DuPage Water Commission

AGENDA – Engineering and Construction Committee

X. **Resolution R-66-25:** A Resolution Awarding a Contract for the Construction of the West Transmission Main along Book Road from 75th Street to the ComEd R.O.W. (Contract TW-6/25 Section 1 (Book Road)) (**D. Construction, Inc. & Benchmark Construction Co., Inc. Joint Venture - $67,148,000)**

XI. **Resolution R-67-25:** A Resolution Approving and Ratifying Certain Change Orders for the Construction of the West Transmission Main Along Book Road From 75th Street to the ComEd R.O.W. (Contract TW-6/25 Section 1 (Book Road)) **(D. Construction, Inc. & Benchmark Construction Co., Inc. Joint Venture – A Decrease in Contract Price from $67,148,000 to $47,301,059.73 plus an Owner's Allowance of $1,000,000).**

CIVIL
WATER TRANSMISSION MAIN
DETAILS
SHEET 5 OF 29

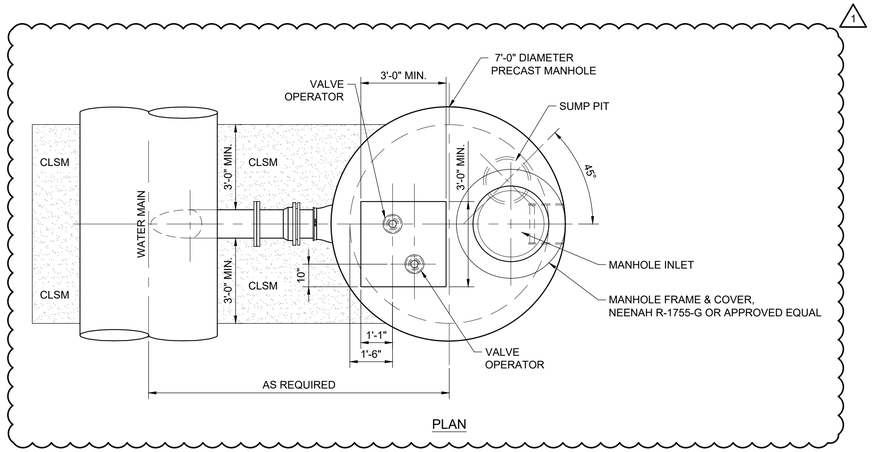
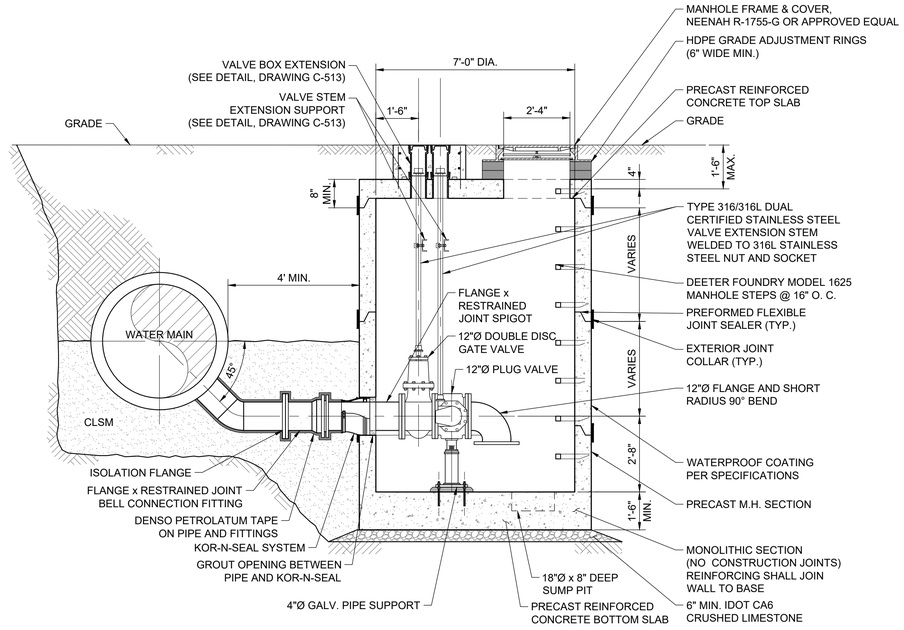
N. Revise Sheet 57 of 199 (Drawing C-522) as follows: Revise all stations in Detail titles from “STA 756+07” to “STA 752+80”.

ELECTRICAL
REMOTE OPERATED VALVE DETAILS
SHEET 1 OF 4

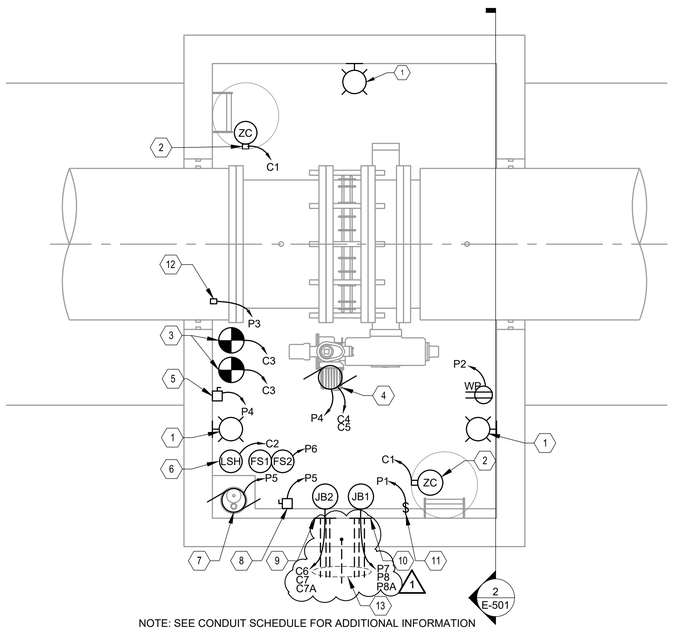
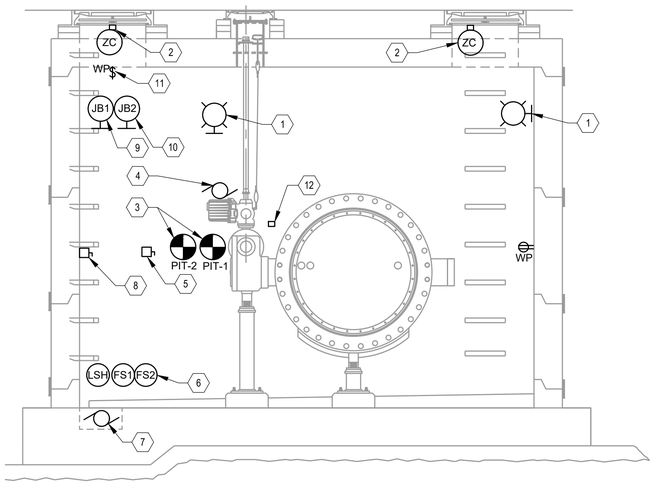
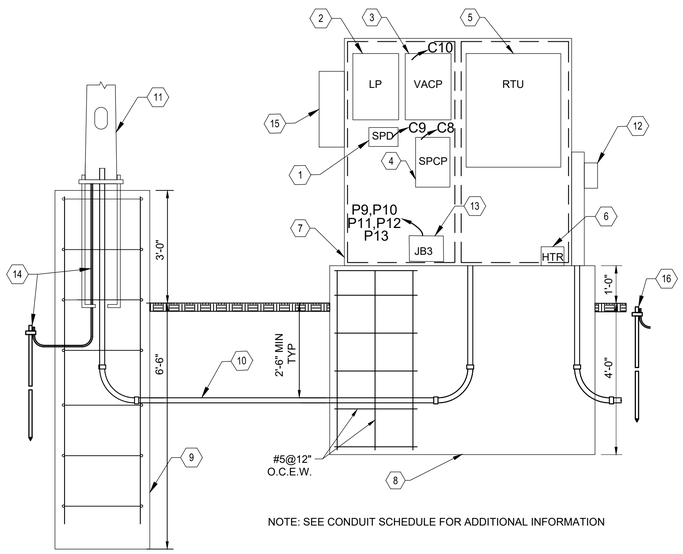
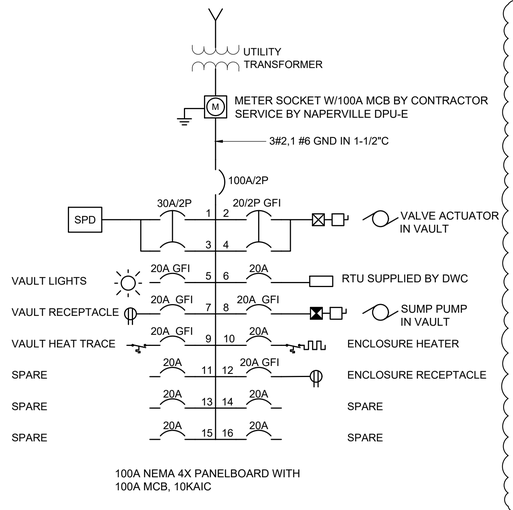
O. Remove Sheet 72 of 199 (Drawing E-501) in its entirety and replace with the attached revised Sheet 72 of 199.

ELECTRICAL
REMOTE OPERATED VALVE DETAILS
SHEET 2 OF 4

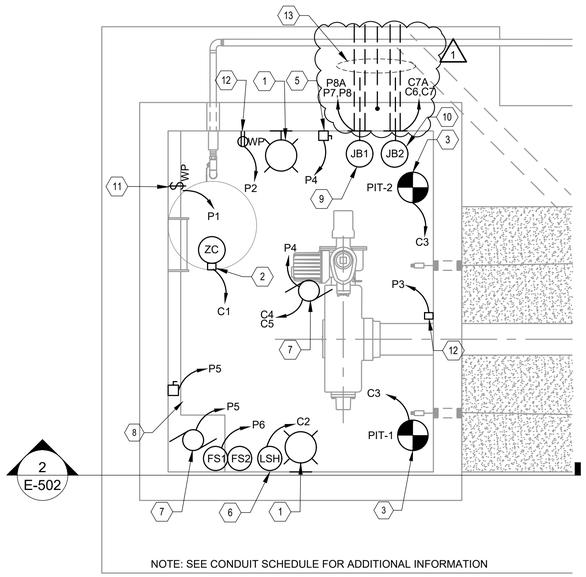
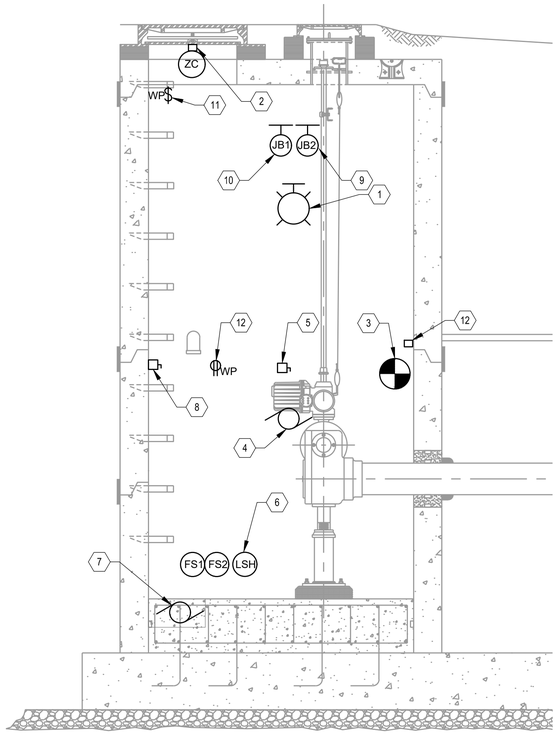
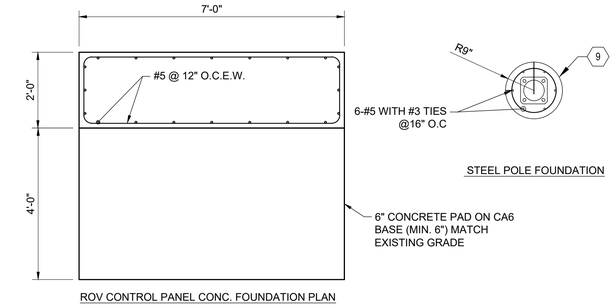
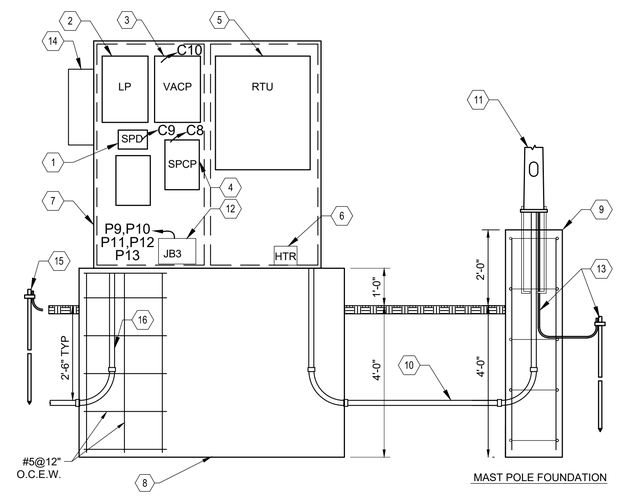
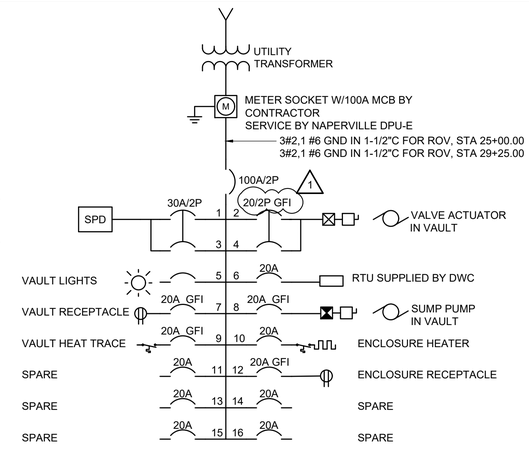
P. Remove Sheet 73 of 199 (Drawing E-502) in its entirety and replace with the attached revised Sheet 73 of 199.

ELECTRICAL
REMOTE OPERATED VALVE DETAILS
SHEET 3 OF 4

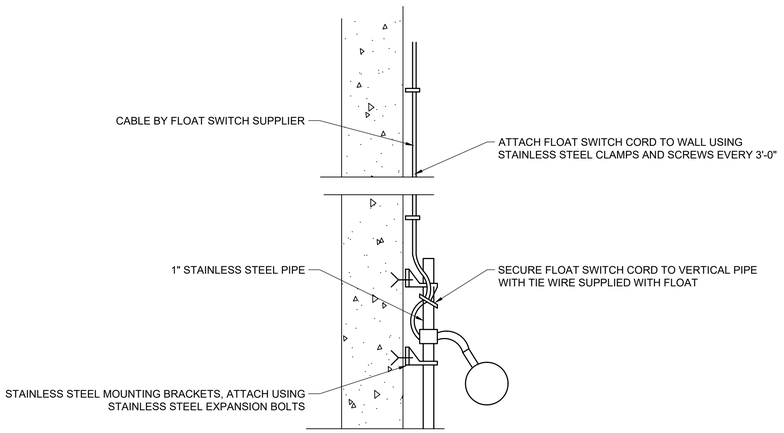
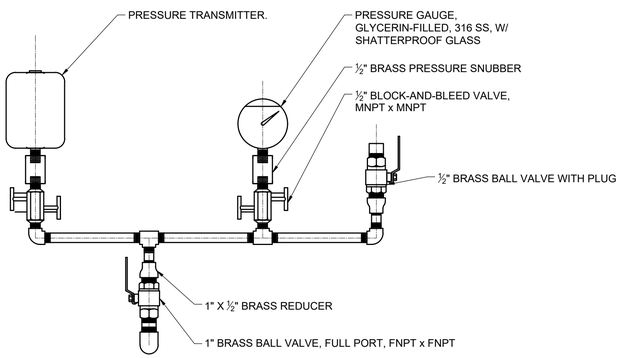
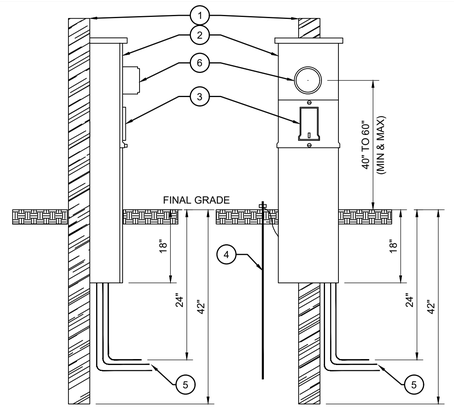
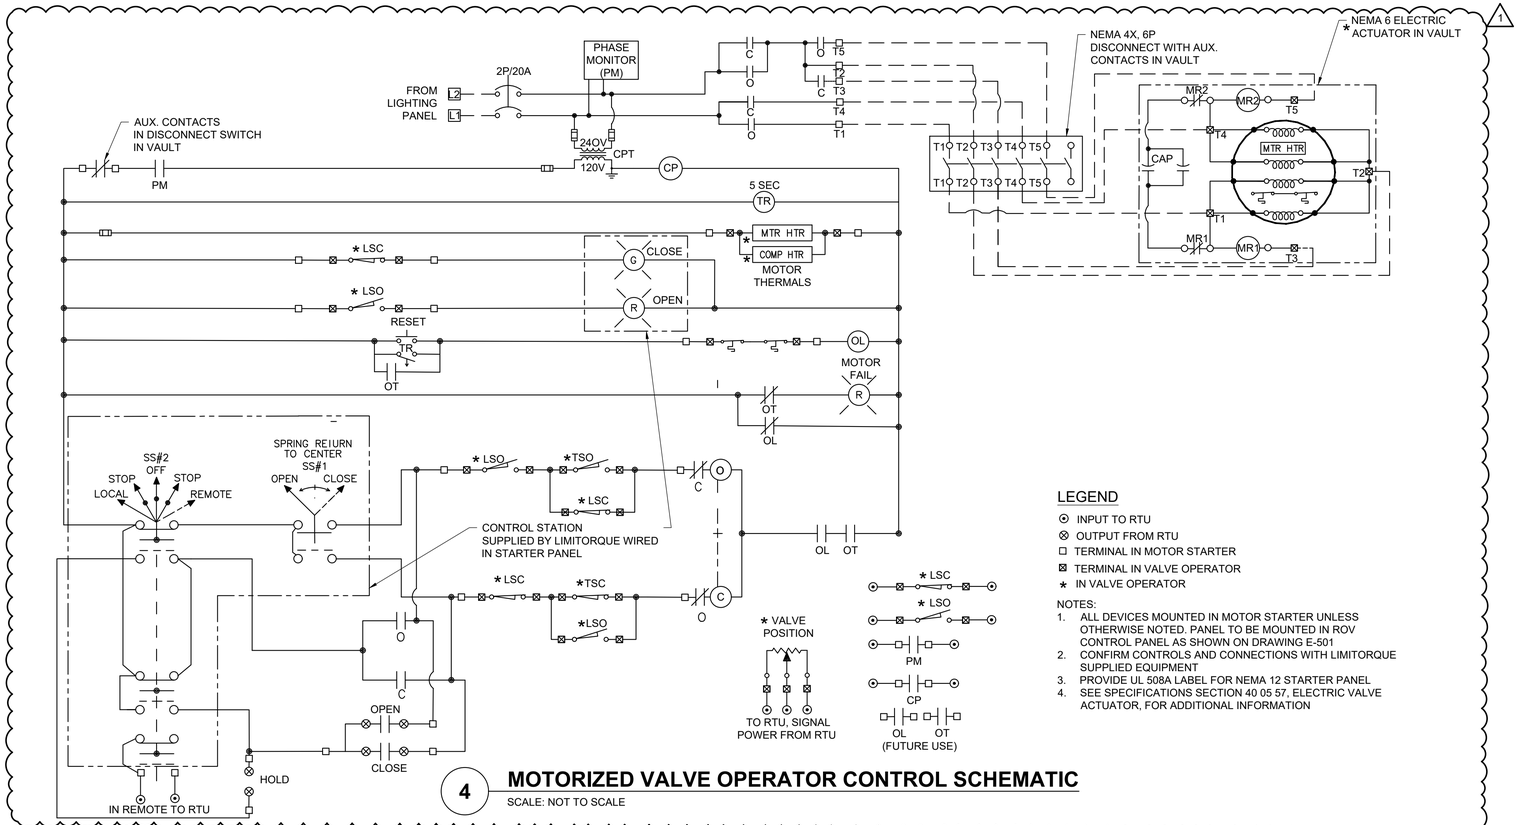
Q. Remove Sheet 74 of 199 (Drawing E-503) in its entirety and replace with the attached revised Sheet 74 of 199.

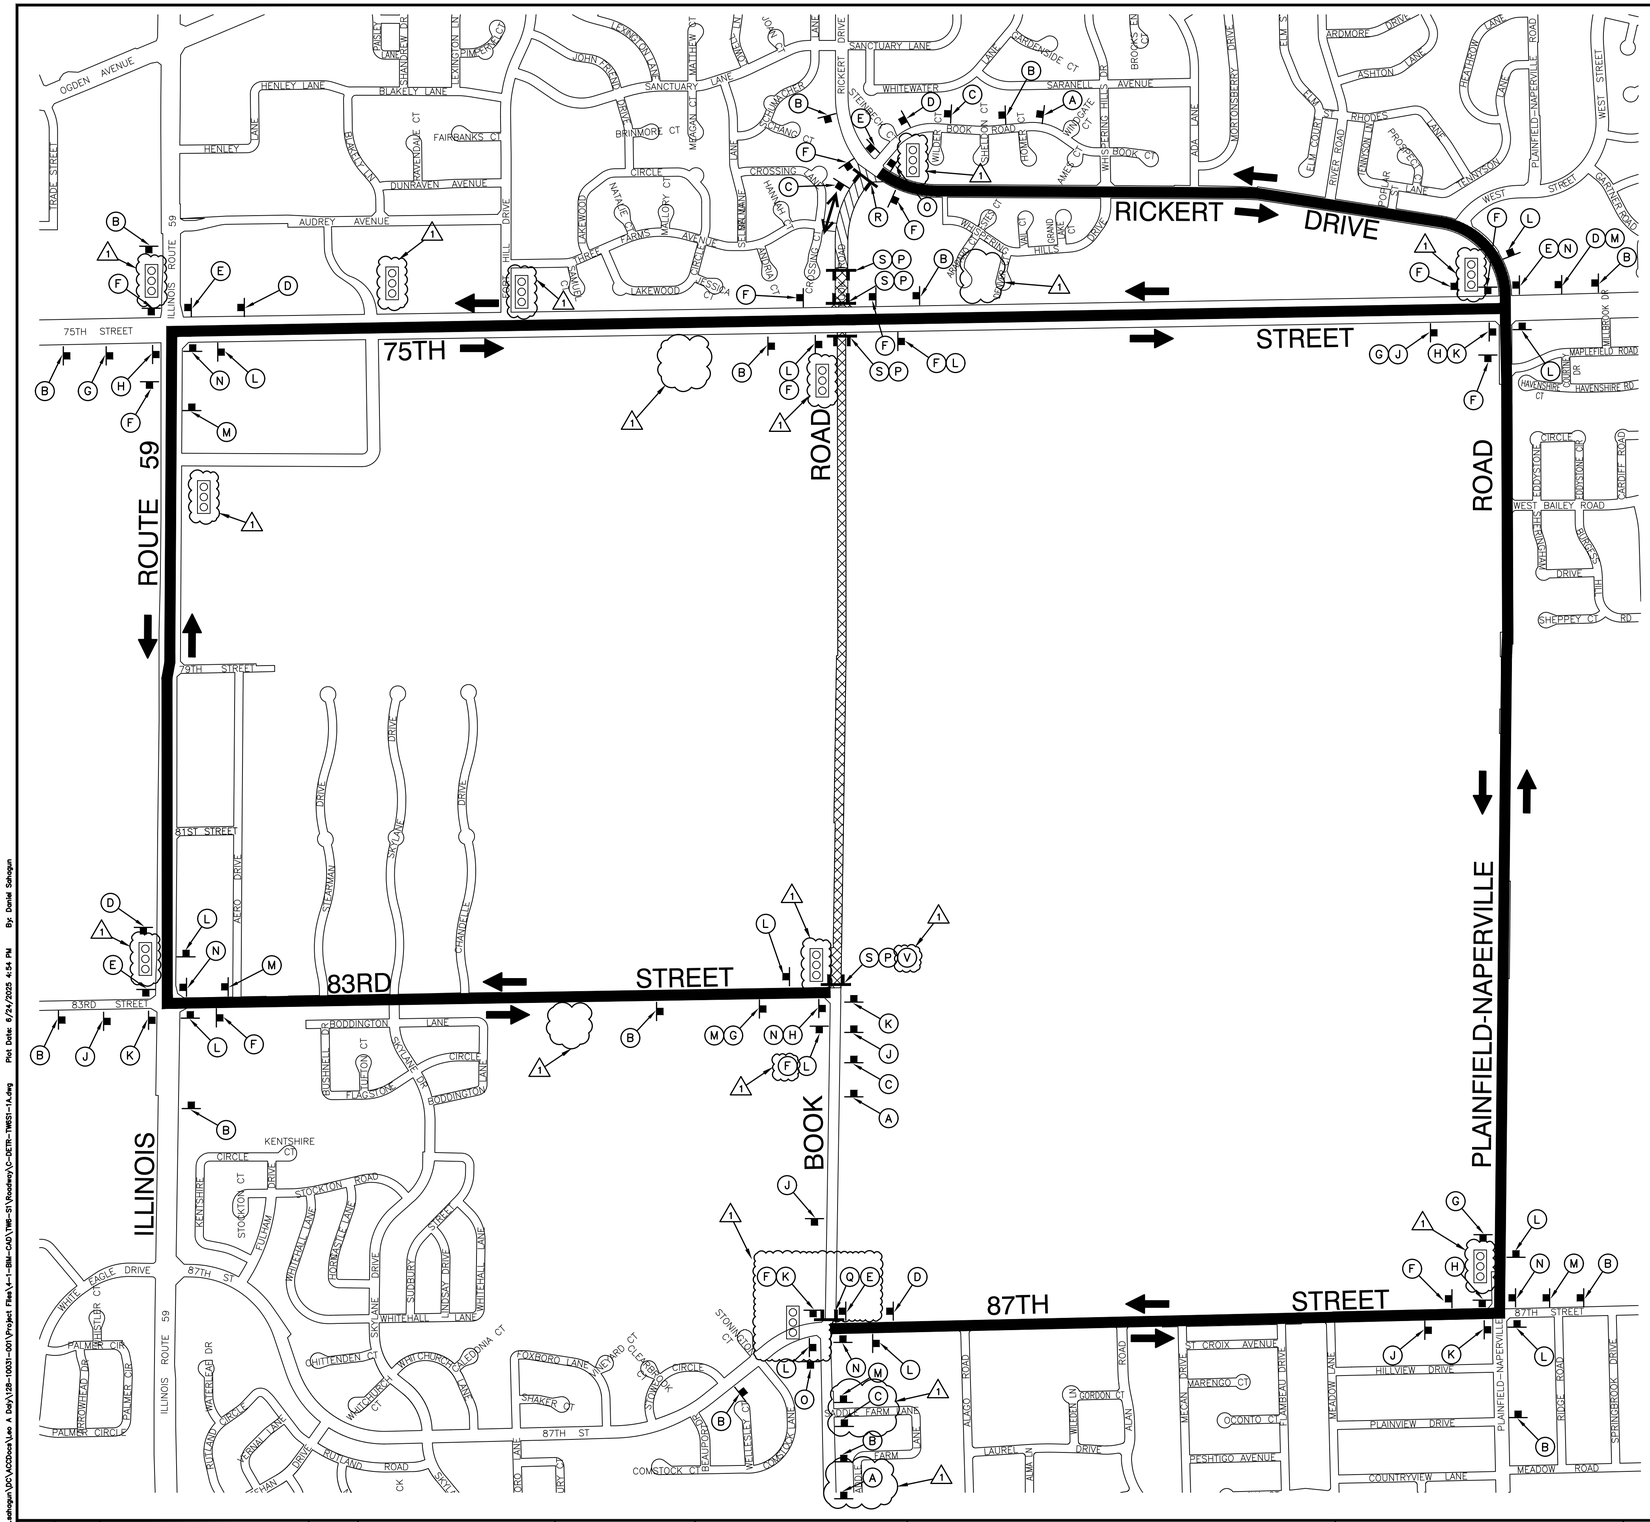
A. Replace Sheet 118 of 199 (Drawing MOT-000) to address comments from IDOT Permits for use of IL Route 59 for Detour Routes. Updated General Notes to revised lettering on D3-1 signs to 5" and added 3 additional General Notes. Revised Detour Route Timing Impacts Table to remove timing for Stage 2B and 3A for IL Route 59 at 75th Street and IL Route 59 at Beebe Drive.
